Access Compliance Report Public Rights-of-Way (Curb Ramps)

Main Street: O_NEILL_DR		Cross Street: CROWN_VALLEY_PKWY		Location:	NW
ADA ID: RPRK211025135043	Ramp Type: Type 4 - Parallel	Initial Pass/Fail: Fail	Overall Compliance: No	Severity Score:	15
Codes/Mitigation Info/Possible Solution			Field Measurements/Component Compliance

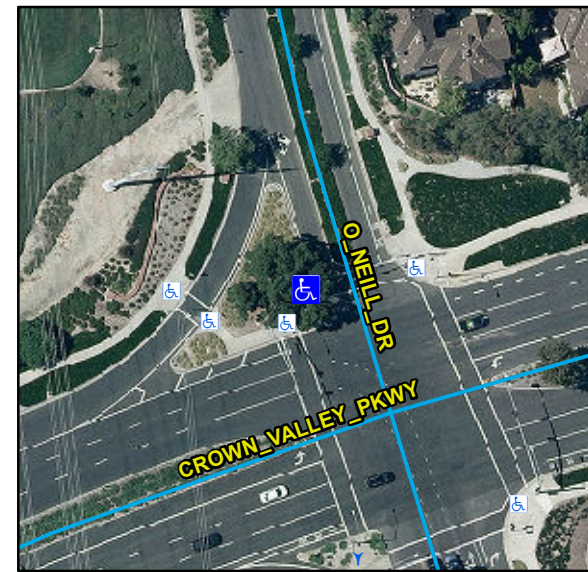
R204.3, R304.3.2, STD 1115

Compliance	Description	Data	Compliance	Description	Data
N/A	Ramp Length LT (in)	108	N/A	Ramp Length RT (in)	117
Yes	Ramp Width LT (in)	82	Yes	Ramp Width RT (in)	82
Yes	Ramp Run Slope LT (%)	3.8	No	Ramp Run Slope RT (%)	9.8
Yes	Ramp Cross Slope LT (%)	0.5	Yes	Ramp Cross Slope RT (%)	1.3
N/A	Landing Present	N/A	N/A	DWS Provided	N/A
N/A	Landing Length (in)	N/A	N/A	DWS Contrast	N/A
N/A	Landing Width (in)	N/A	N/A	DWS Length (in)	N/A
N/A	Landing Run Slope (%)	N/A	N/A	DWS Full Width	N/A
N/A	Landing Cross Slope (%)	N/A		DWS Offset Type	N/A
N/A	Landing Movement Obstructed?	N/A	N/A	DWS Offset Left (in)	N/A
	Landing Movement Type	N/A	N/A	DWS Offset Right (in)	N/A
N/A	Landing Shared	N/A			
N/A	Clear Space	N/A			
N/A	Clear Space To Crosswalk (in)	N/A			
N/A	Marked Crosswalk 1	Yes	N/A	Marked Crosswalk 2	N/A
	Crossing 1 Direction	E		Crossing 2 Direction	N/A
	Marked Crosswalk 1 Width (in)	145		Marked Crosswalk 2 Width (in)	N/A

Remove & Replace Entire Ramp.
